**ADDENDUM NO1**Date: **March 27, 2026**Project No.: **2596**Project: **Alderville Senior's Residence  
Renovations**

The following information, amendments and revisions shall constitute Addendum No 1, and shall form an integral part of the Tender Documents and where applicable, shall supersede requirements of other Tender Documents.

Date: March 26, 2026  
Project: Alderville Seniors Residence  
Renovation  
Project No: 25-088  
No: ADD-ME01

Drawing No:  
**E201** Revision:  
**1**

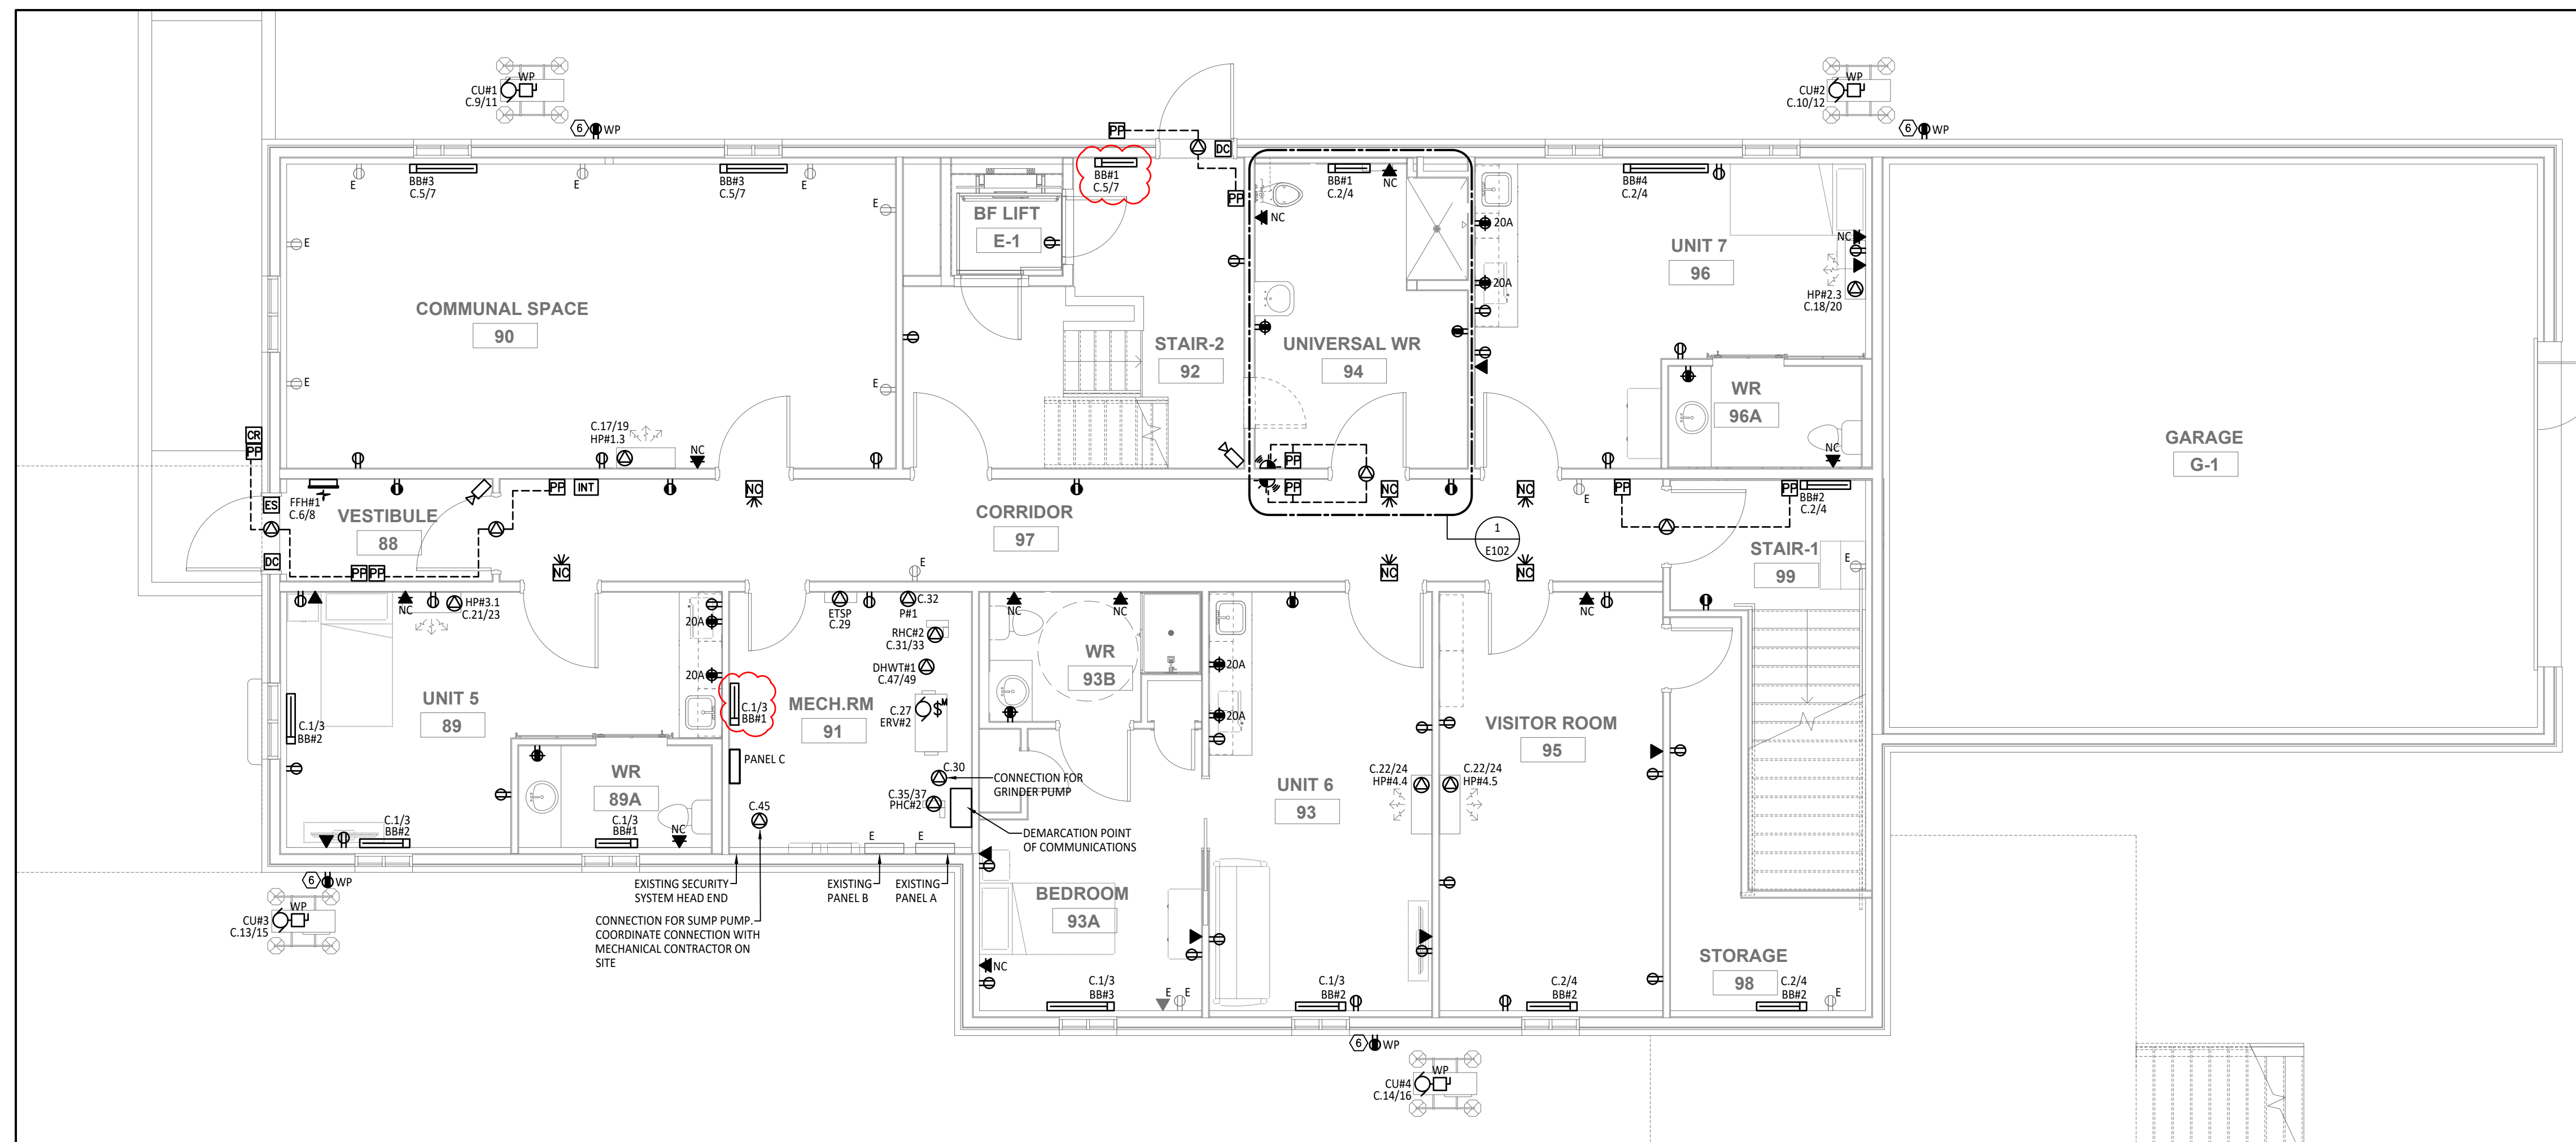
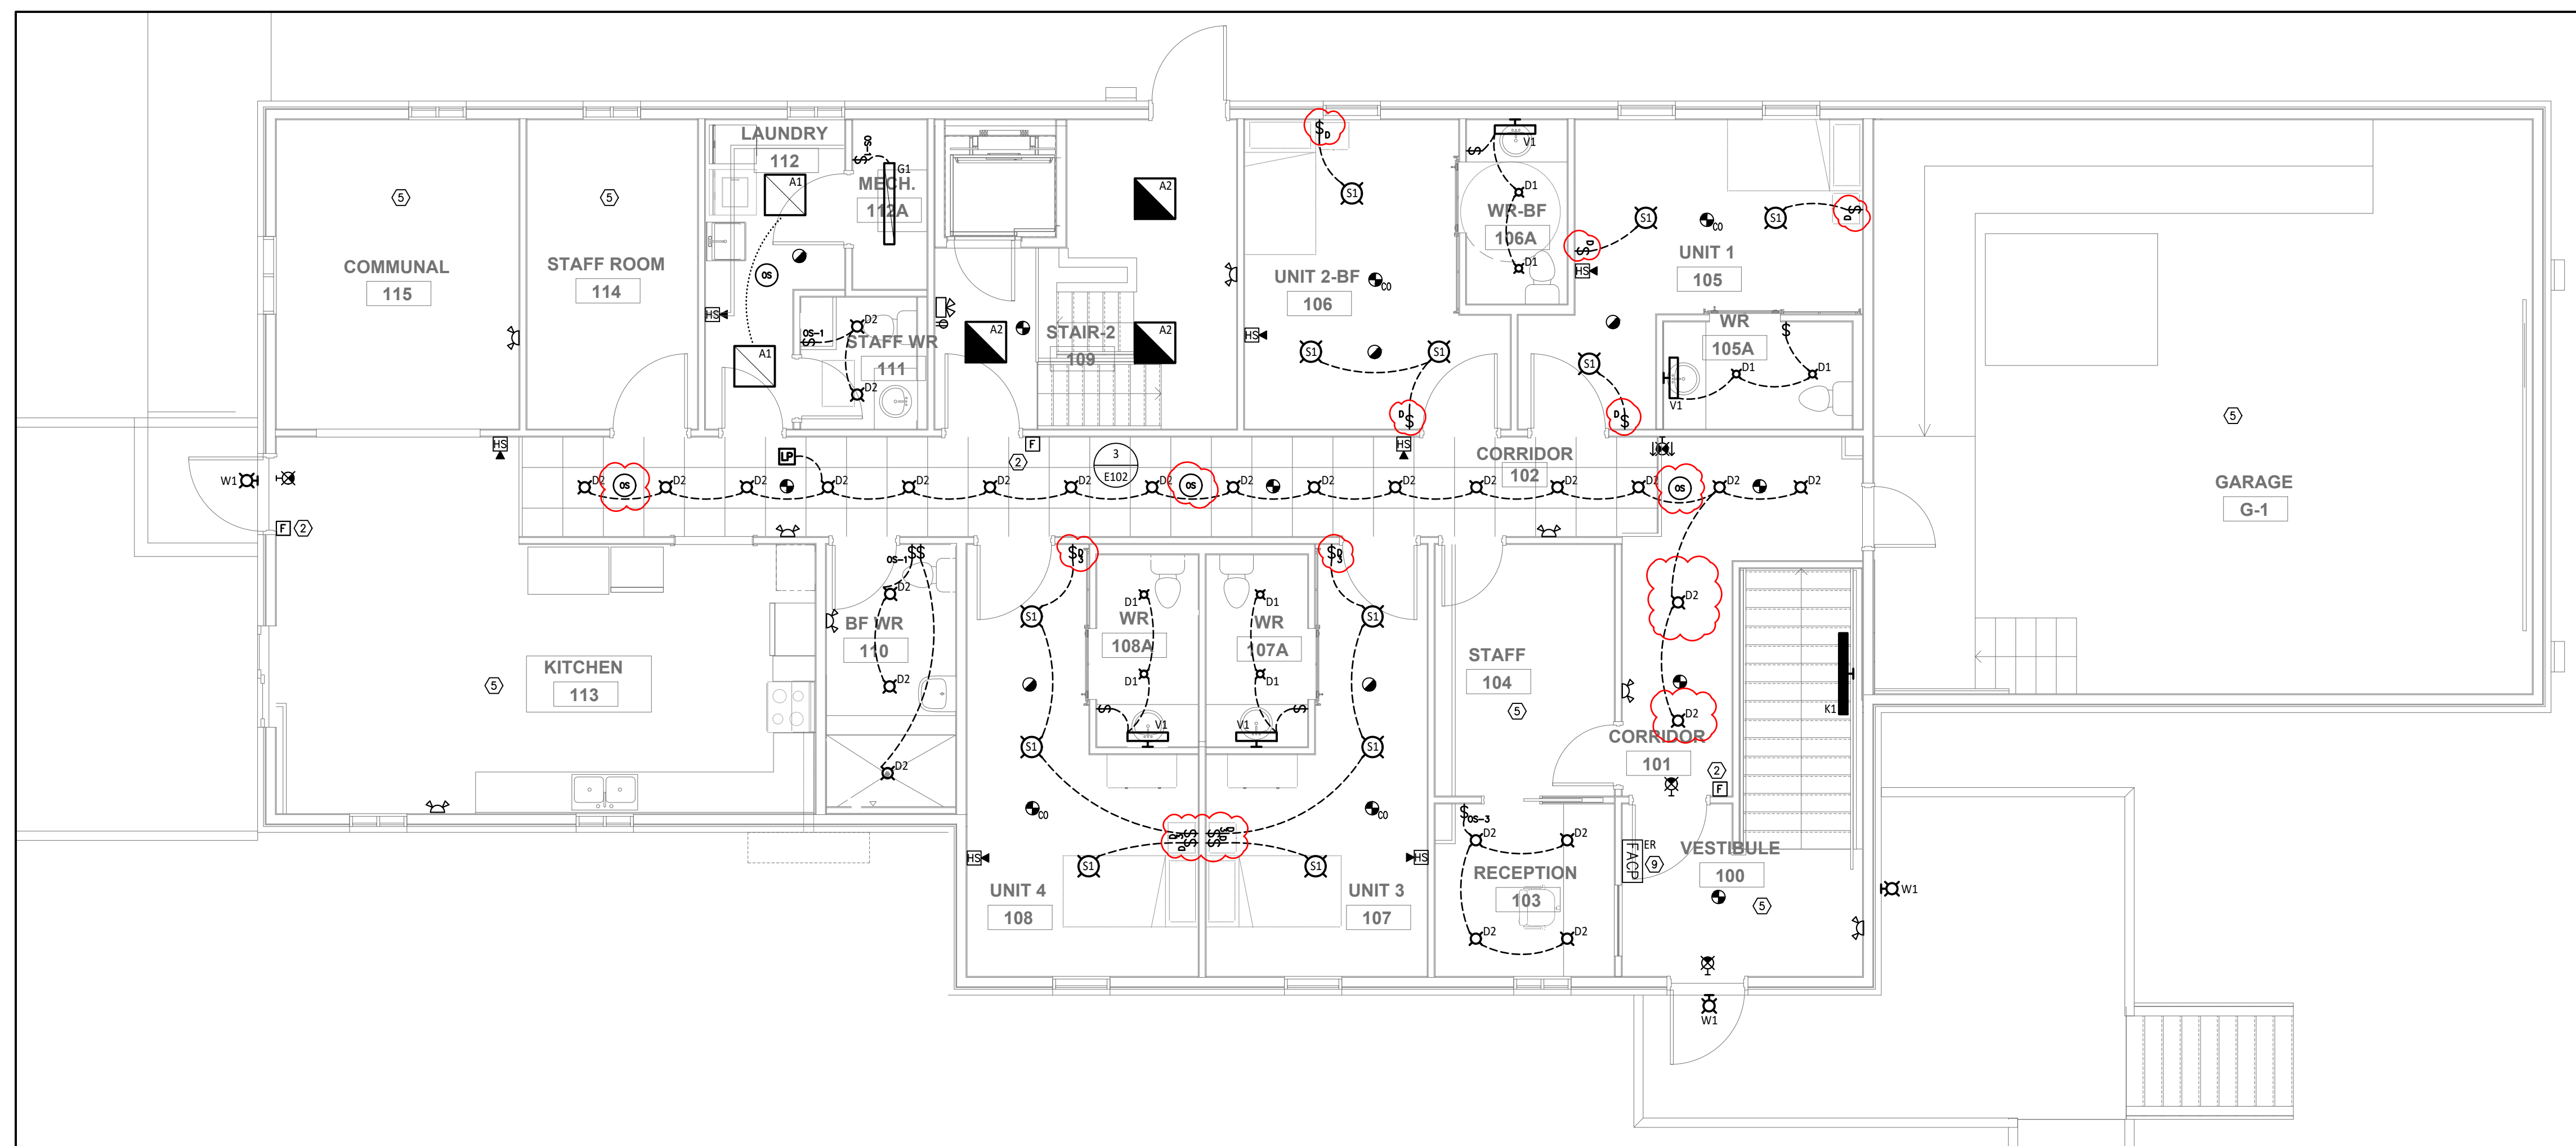
**1 REGARDING ELECTRIC BASEBOARD COORDINATION (DRAWING E201 RE-ISSUED)**

.1 Refer to attached drawing for revised baseboard locations.

Drawing No:  
**E301**

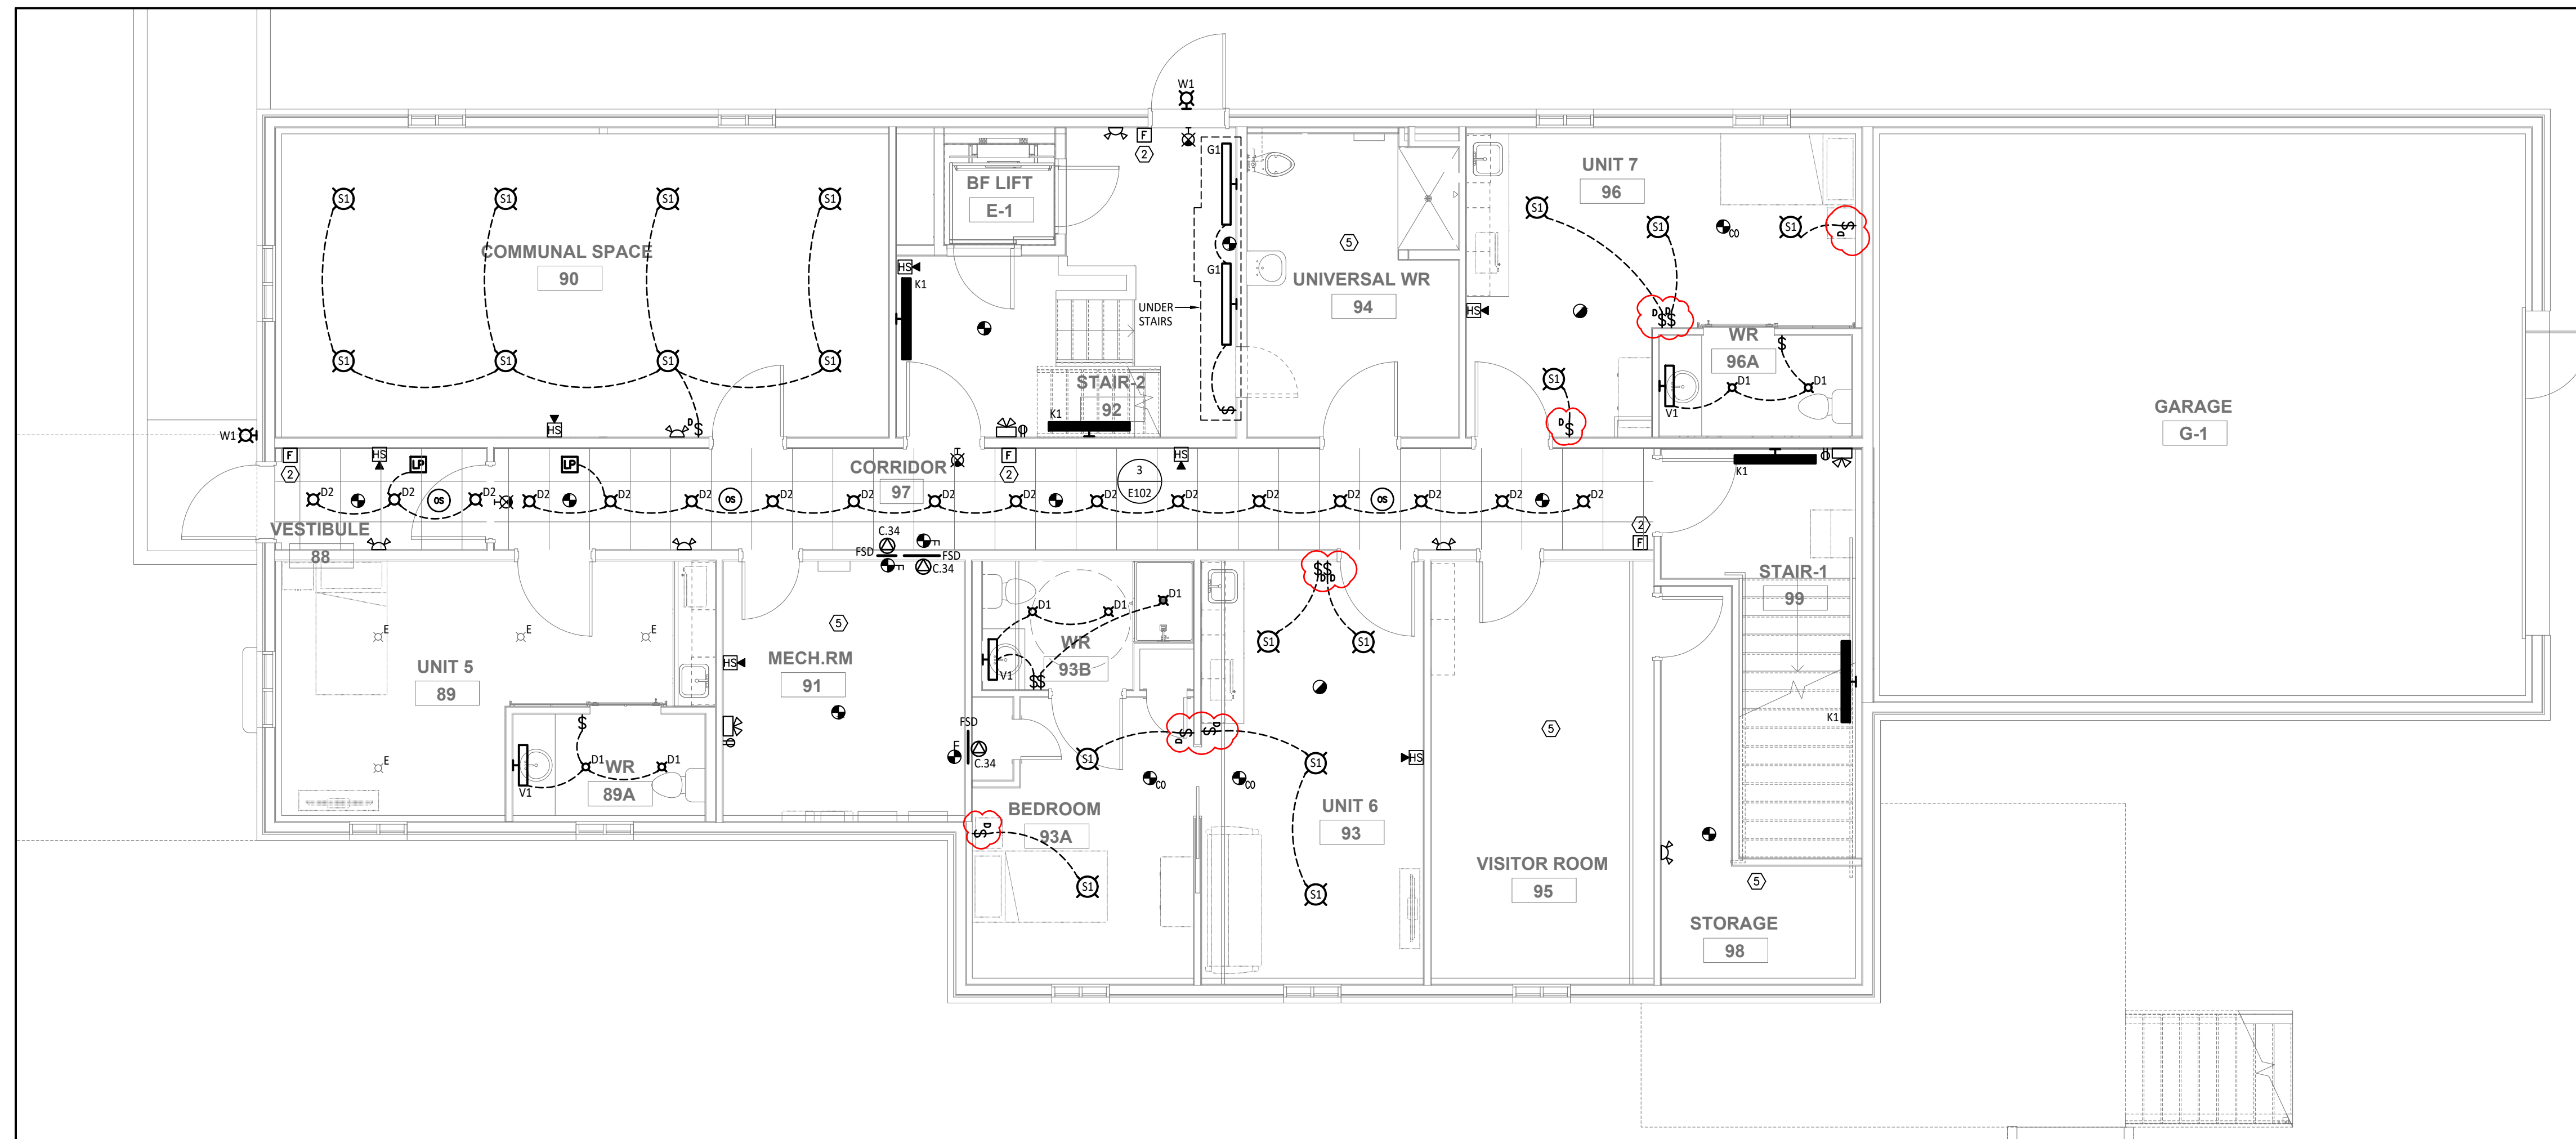
**2 REGARDING LIGHTING COORDINATION (DRAWING E301 RE-ISSUED)**

.1 Refer to attached drawing for the following revisions:

.1 Revised suit light switches to include for dimming.

.2 Coordination of recessed fixtures in the first-floor corridors.
